TECHNICAL BULLETIN

REF NO: 104.95

PRODUCT: VF7-10 VIEWFINDER FOR HK-366 / HK-377

SUBJECT: RASTER SCAN SIZE SWITCHING

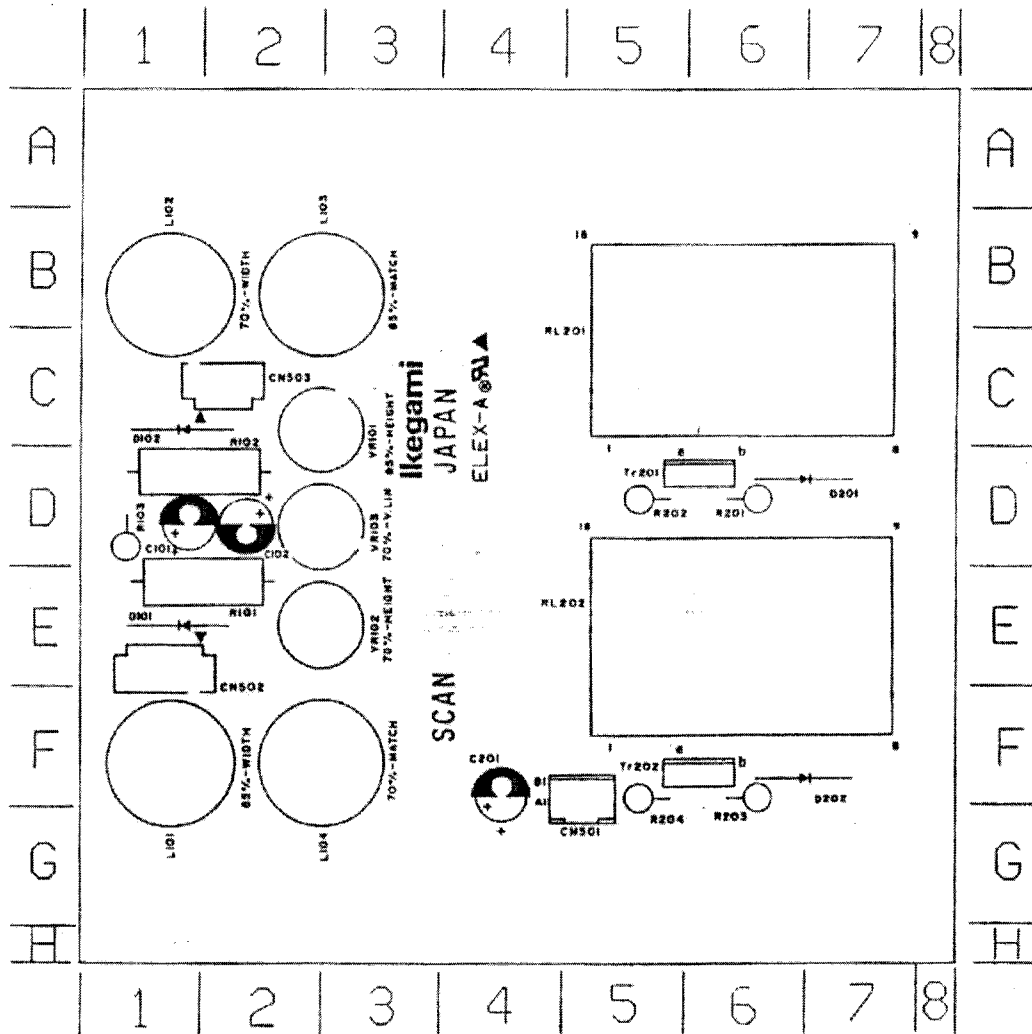
The following modification should be used if erratic operation of the SCAN SIZE select feature is encountered.

1. Locate the VF SCAN BOARD
2. Remove resistors R201 and R203 (see figure #1)
3. Replace these resistors (10K Ω) with 6800 Ω 1/2W resistors (Part# ERDS1VJ682T or equivalent)
